## Chapter 9 – Visual Impact measurement

Where Cloustons try to minimize the number of properties visually impacted and further, minimize that impact for each property.

The first private receptor evaluated is J157 (Viewpoint 10, LVIA P 80).

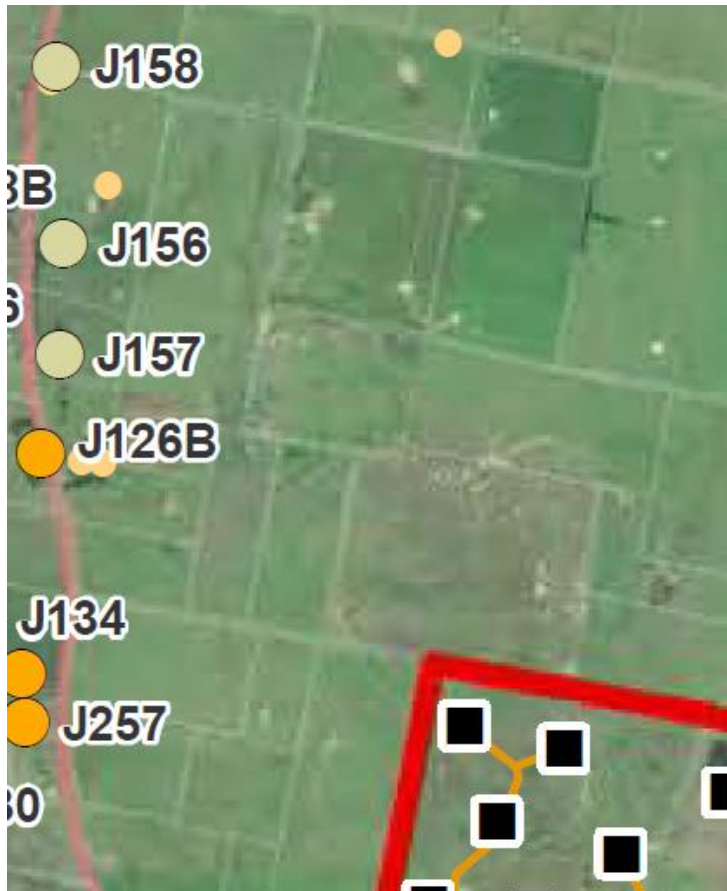
J157 was judged by Cloustons from this position on the road to have a visual impact of Moderate/High and after the application of the magical vegetative mitigation was deemed to have a visual impact rating of Moderate/Low. Cloustons advise that this was a “worst case scenario”.

The photograph, if taken from the residence, would show the turbines closer and more prominent. Cloustons list the distance to the nearest turbine (from the viewpoint?) as 2.4 km. ERM advises that the residence is 2104 metres from the nearest turbine,<sup>2</sup> even closer from the curtilage, even closer after micro-siting. The line of screening trees was there before the recently built residence. Note, there has been no attempt to plant additional screening to block out the view that the Jupiter wind farm will destroy. Also a view from the clearly defined curtilage of this property would most likely see most of the turbines in the rest of the northern precinct (Jupiter Central as we call it)

This is also a clear example of how misleading these “representative” viewpoints can be. This viewpoint covers properties J158, J156, J157, and J126B. J158 is the furthest away from a turbine. J126B is the closest. The viewpoint is between residences J156 and J157. (Viewpoint GPS coordinates would appear to be missing from the EIS). The associated and misleading wireframe WF 10, LVIA Page 207, was taken from J158, as indicated. With J158 being the furthest residence from turbines in this representative group, how can you justify that this wireframe is representative.

So, if we had taken the closest residence (under 2km) of this representative group, then DISTANCE would have been HIGH in the matrix even under Cloustons flawed matrix distance factor.
